Service Bulletin FSN-30

Subject: NC-300 Changes

Bulletin Number FSN-31

Bulletin Number FSN-34

- NOTE -

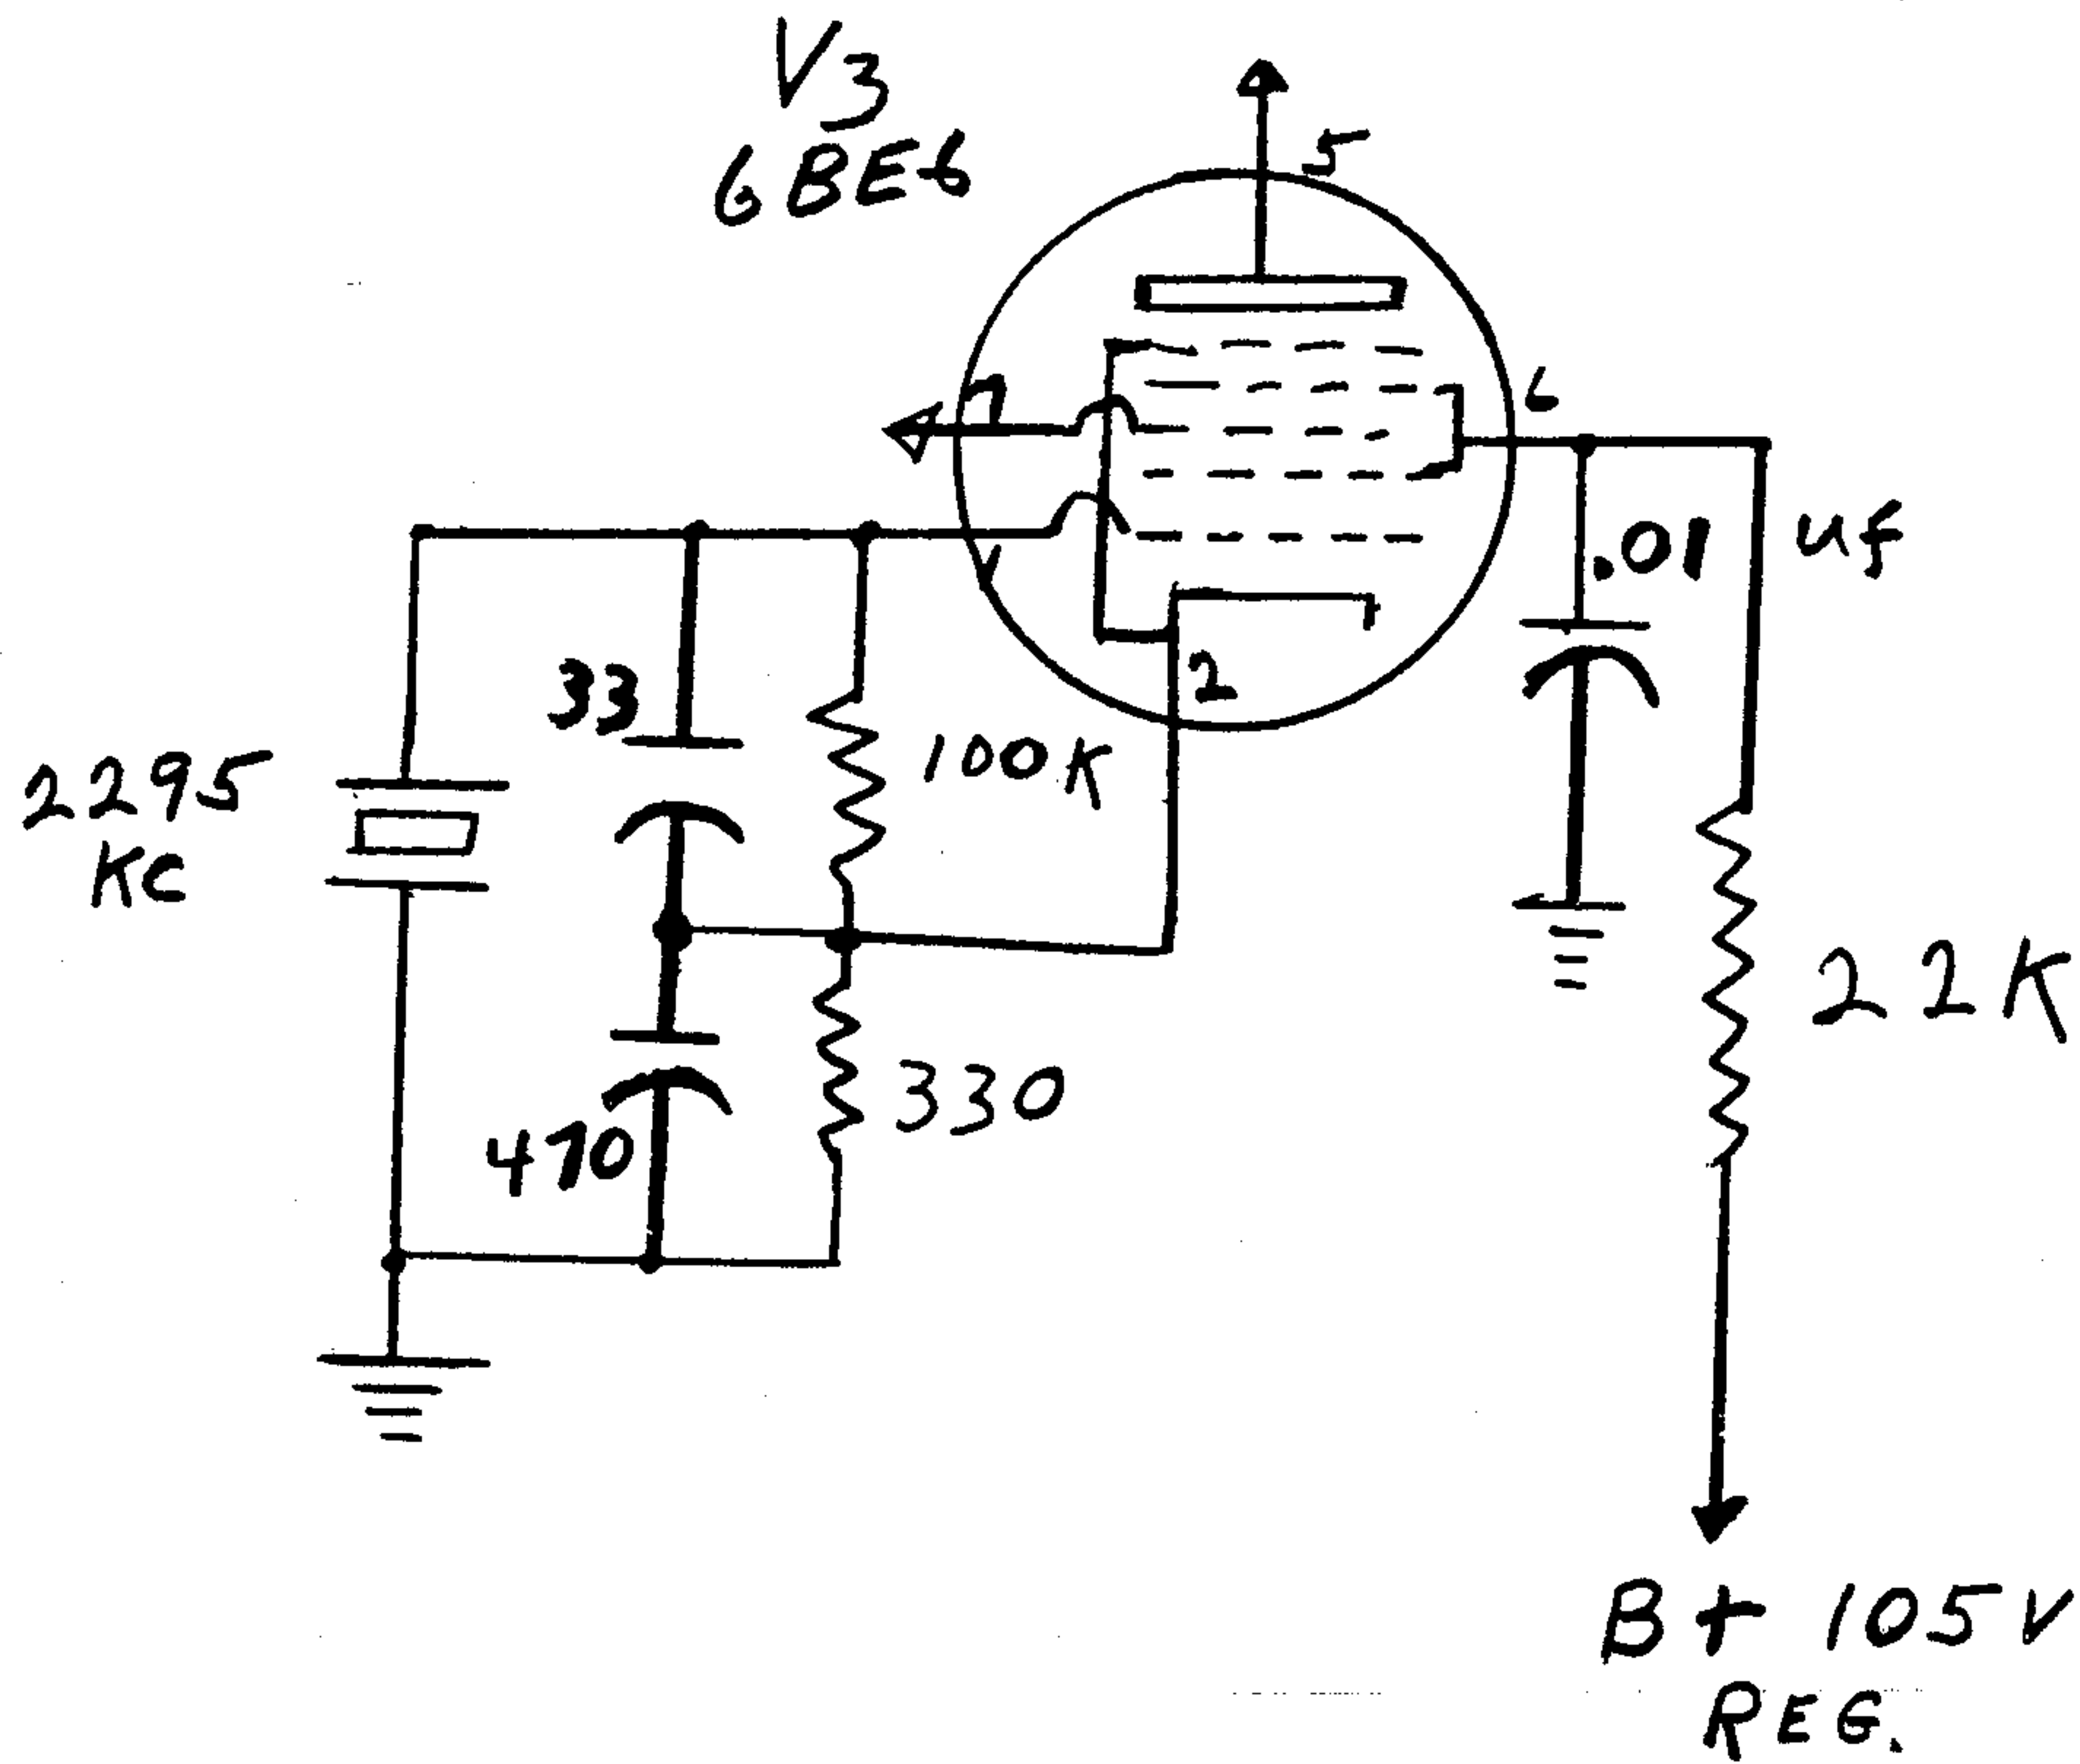
In these instances we recommend crystal control of the second conversion oscillator as per the attached schematic. It should be remembered that there are now two crystals in the circuit which must be properly coordinated if the receiver is to work at maximum efficiency. Normal production tolerances in the grinding of the crystals may allow a situation to exist where the difference in frequency of the crystal in the crystal filter (2215 kc) and the crystal in the second conversion oscillator (2295 kc) is not exactly 80 kc (second IF).
